Re: FortisBC Energy Inc. (FEI)

Application for a Certificate of Public Convenience and Necessity (CPCN) for the Tilbury Liquefied Natural Gas (LNG) Storage Expansion (TLSE) Project (Application)

Response to the Citizens for My Sea to Sky Society (MS2S) Information Request (IR) No. 2

Figure 14: Comparison of Natural Gas and Electric Annual Outage Rates

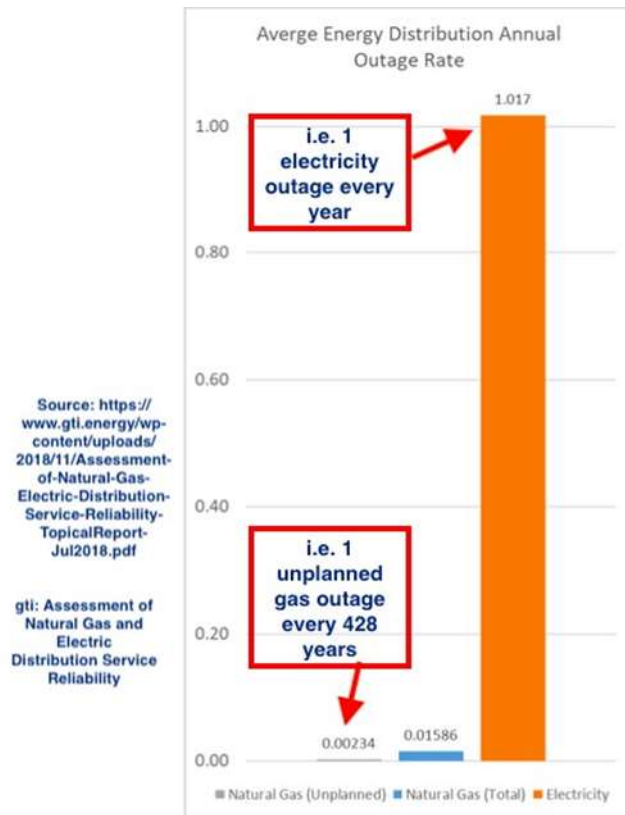
1 **Issue 1: Need - event probability.** A key issue in this application is the reliability of the T-South
 2 pipelines. In our IR#1 submission, we presented evidence from a gas-industry reference¹ provided
 3 in FEI's December 2020 CPCN application. That reference showed that the frequency interval for
 4 unplanned outages of North American gas pipelines averaged 428 years. The key finding of that
 5 research – derived from PHMSA's 2005-2016 Gas Distribution- Serious Incidents database- is
 6 reproduced opposite. The report highlighted that electric infrastructure is considerably more
 7 vulnerable to weather conditions such as high winds (e.g. hurricanes, tornadoes), ice storms, and
 8 other weather events. In contrast, underground natural gas pipelines have proven reliable and
 9 resilient throughout many major weather events.

Figure 1: RNG Production Potential without Technology Advancements at \$28/GJ

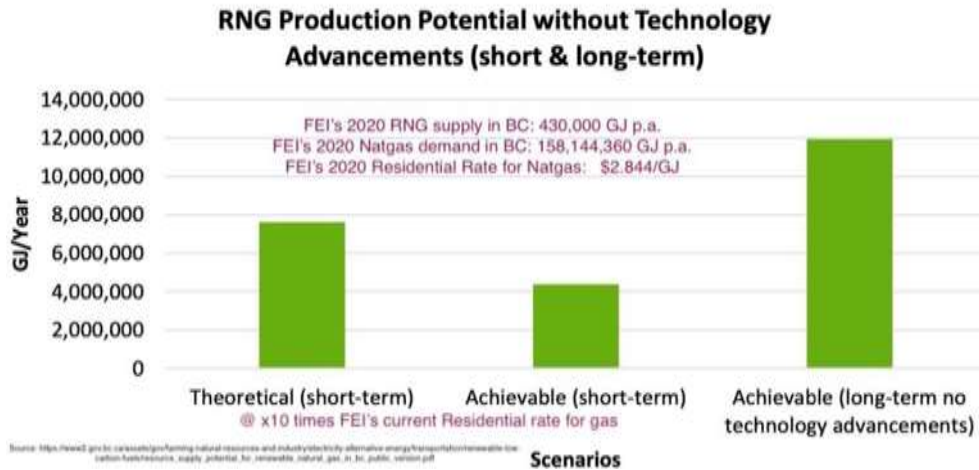
2 As the BC-Government supplied graph opposite shows, the current supply of RNG is a tiny (0.3%)
 3 proportion of FEI's NG supply, and prospects for increasing it to 15% dim, even at prices 10 times
 4 that currently charged.

1 4.7 What short and long-term “technology advancements”, referenced in the BC
2 Government report cited above, does FEI think are vital to achieving the 15% RNG
3 target.
4

6 While FEI did not author this report, it interprets “technology advancements” as relating to two
7 areas which will help to achieve the above-referenced percent RNG target. First, improvements
8 to the efficiency and to lower the cost for biogas upgrading equipment, as well as improved
9 digestate management processes, will enable additional RNG production. Second, the report
10 refers to for the potential development of wood to RNG conversion technology, thereby reducing
11 the cost and increasing the scalability of RNG production.

12 Moreover, the above chart does not appear to account for the potential RNG supply from the
13 forestry sector. In particular, FEI is enabled through the Greenhouse Gas Reduction Regulation
14 (GGRR) to acquire renewable gases in the form of biomethane, synthesis gas and lignin to
15 displace natural gas consumption. Developing supply from this potentially significant source is an
16 area of increased focus for both FEI and the BC provincial government.
